CROW BUTTE RESOURCES, INC.

Mine Unit 1 Restoration Report
Crow Butte Uranium Project

United States Nuclear Regulatory Commission
Source Materials License SUA-1534

Figure 6
Mine Unit 1 Average TDS Concentration

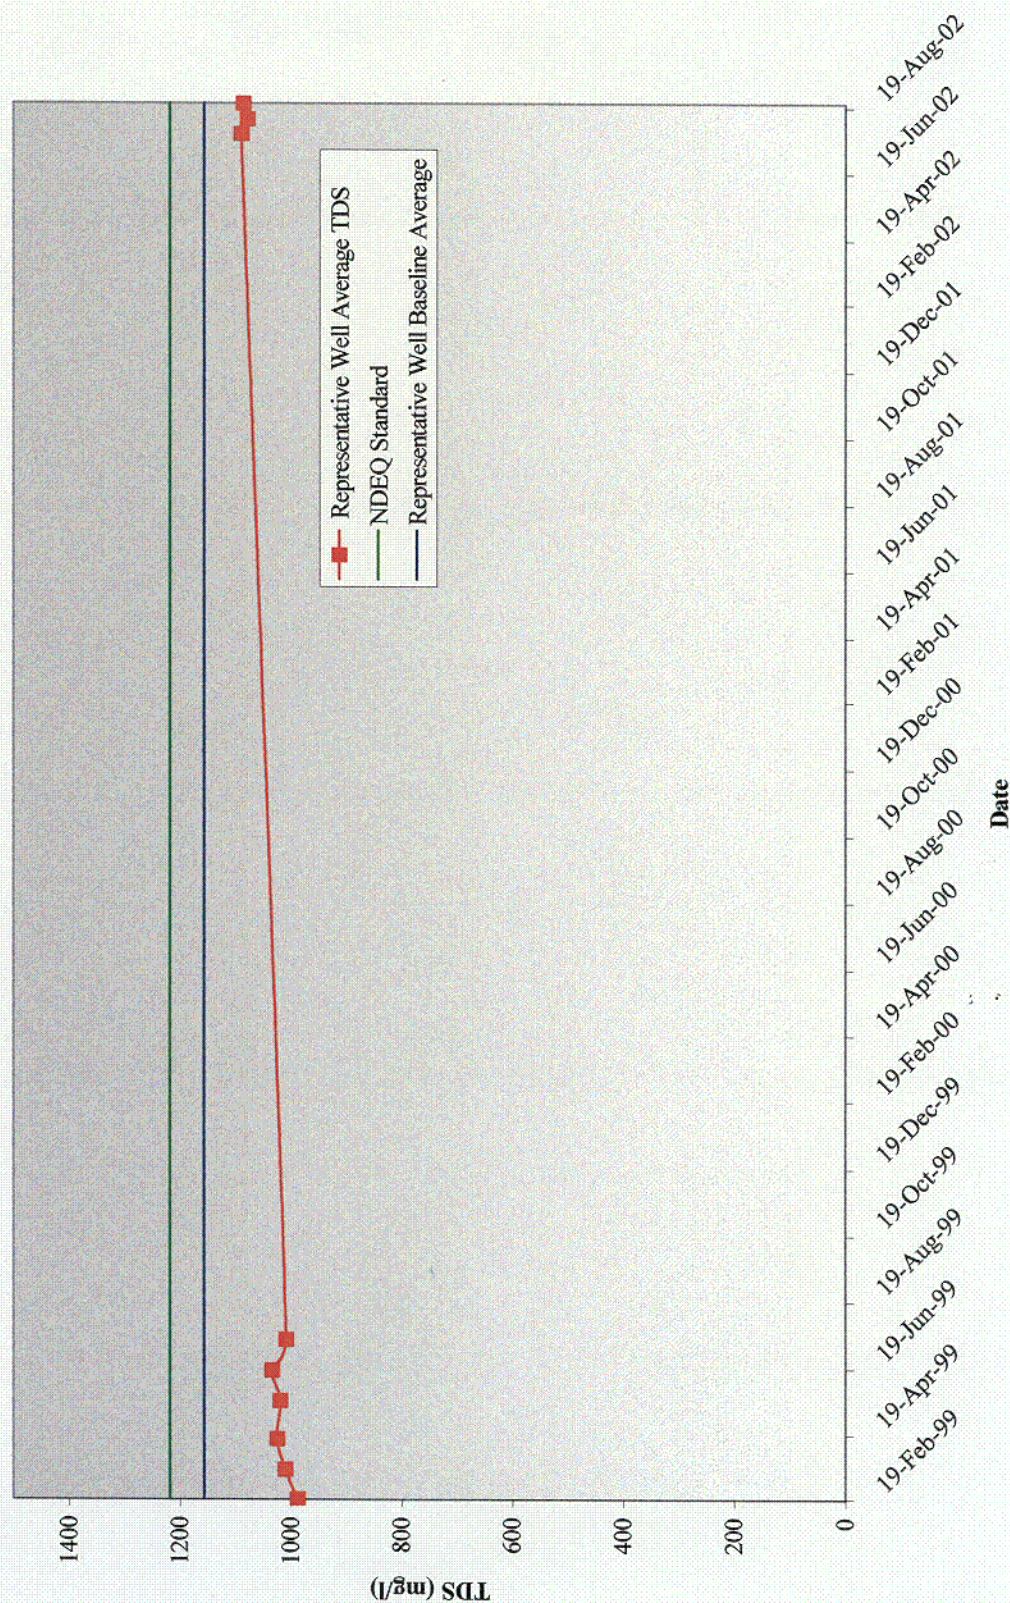
Average Mine Unit 1 Total Dissolved Solids (TDS) concentrations during the stabilization period in 1999 ranged from 1026 to 1153 mg/L, with an average concentration of 1094 mg/L (CBR, 2000). These concentrations compare with the baseline concentration of 1170 mg/L and the NDEQ restoration standard for Mine Unit 1 of 1218 mg/L⁶. Figure 6 plots the average TDS concentration from the six representative restoration wells during stabilization and during the additional monitoring period approved by NRC.

As shown in Figure 6, TDS concentrations are stable at concentrations below baseline and the restoration standard. The average TDS concentrations ranged from 1078 to 1089 mg/L between June and September 2002, with an average concentration of 1084 mg/L.
